Client: **MR M MONFREDI**

Project: **HILL STREET
EISEGAR
NR BARNSLEY**

Drawing Title: **TYPE B**

D 24-02-18 Amended to Planning Requirements
C 19-02-18 Elevations revised as per Planning comments
B 19-01-18 Homes for the details added
Rev: -01-18 Room sizes added

Comparison Elevation

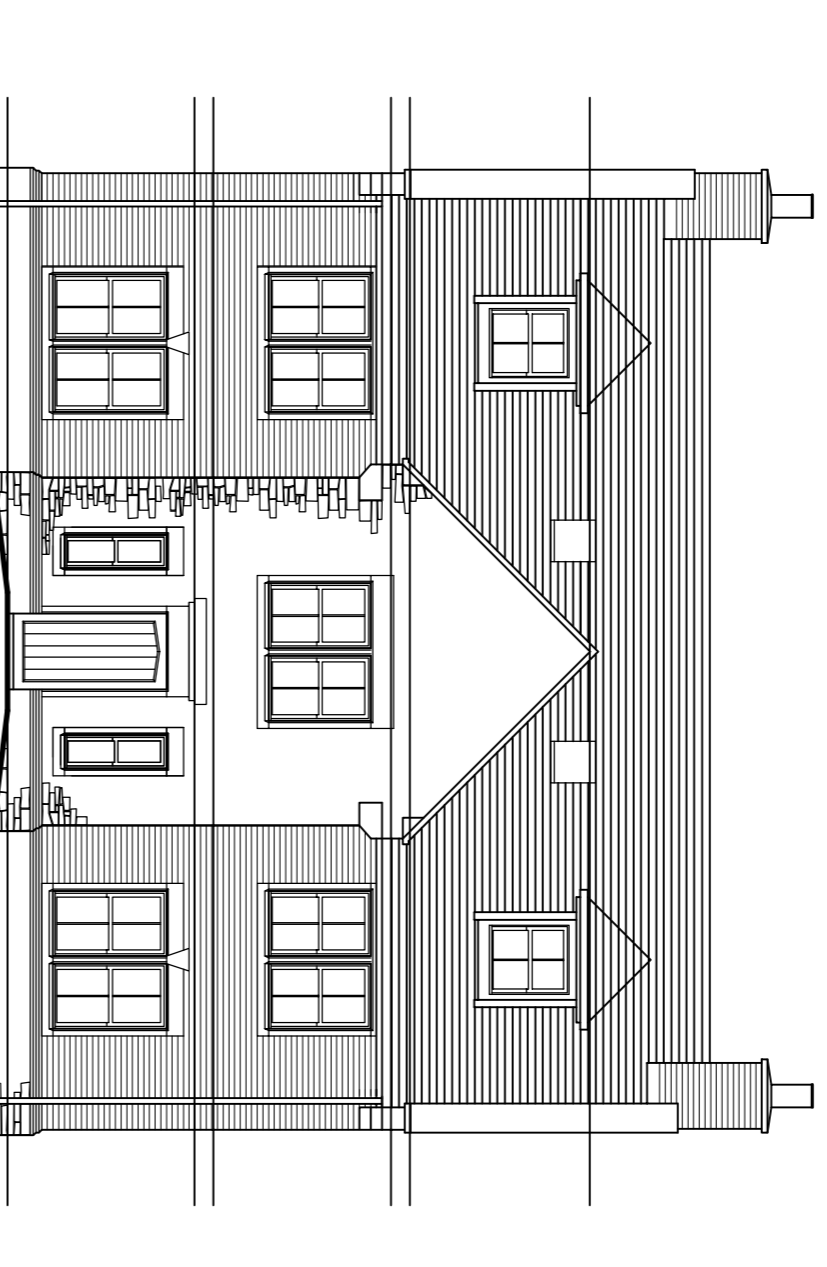
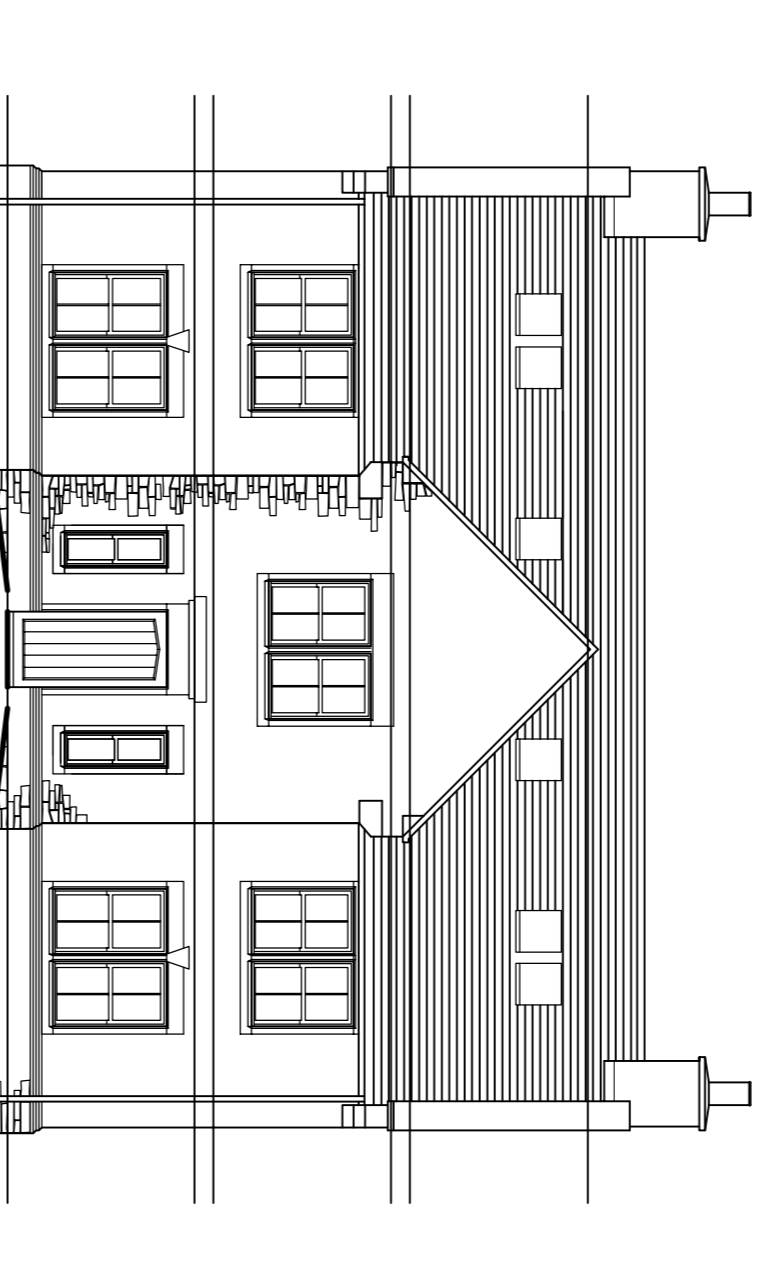
Originally submitted

Revised after comments
